CM13.1. Development Application 10.2021.38281.1 Forty-three (43) Lot Torrens Title Subdivision & Tree Removal - 186 Kaitlers Road & Birubi Road Springdale Heights

DATE	28 September 2021	FIL REFERENCE	AF21/01253
CONFIDENTIAL	No		
FURTHER ENQUIRIES	David Christy City Development	PHONE	6023 8111
AUTHOR	Marius Shepherd

Figure 6: Extract from tree removal map.

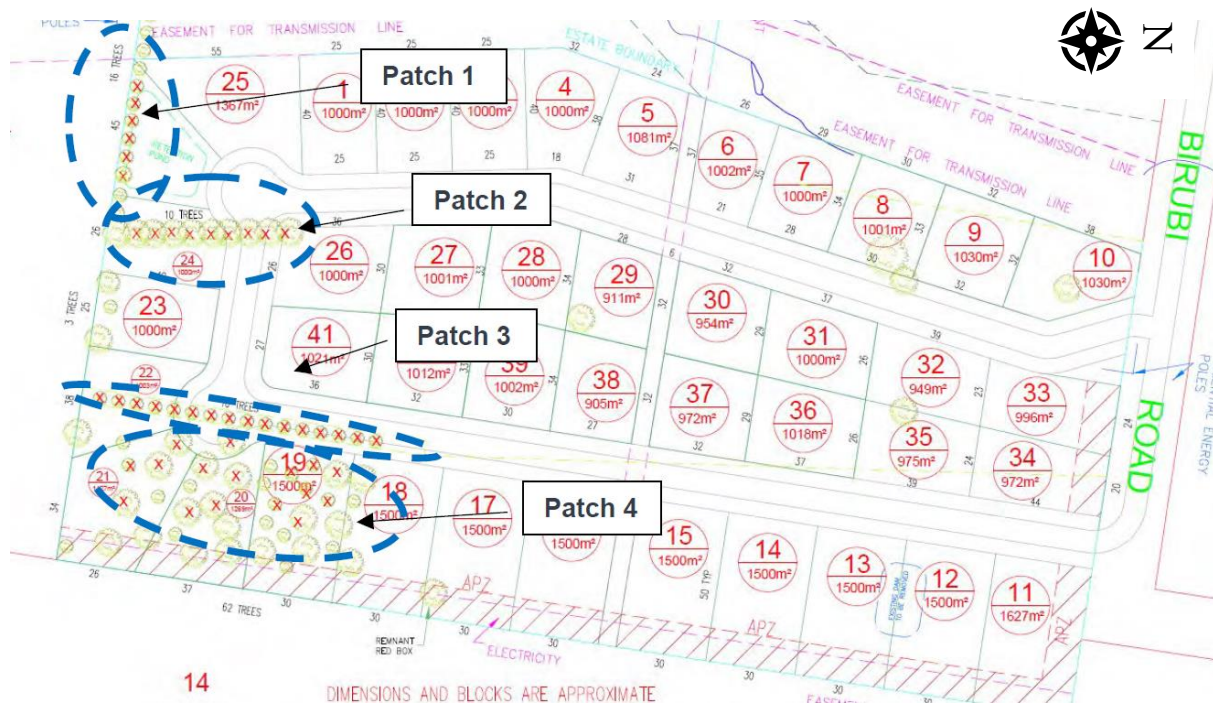
Council's Environmental Planner and Arborist conducted a site inspection and reviewed the information provided by the applicant to verify these findings. They found that it is likely that an additional eight to ten trees would need to be removed to accommodate carriageways/services, etc. They further noted that any trees that are "opportunistically retained" are likely to require removal later at the individual lot development stage. Conditions of Consent were recommended, should Council approve the development, requiring an Environmental Management Plan, a Fauna Management Plan, a Landscape Plan and an Erosion and Sediment Control Plan prior to the issue of a Construction Certificate.
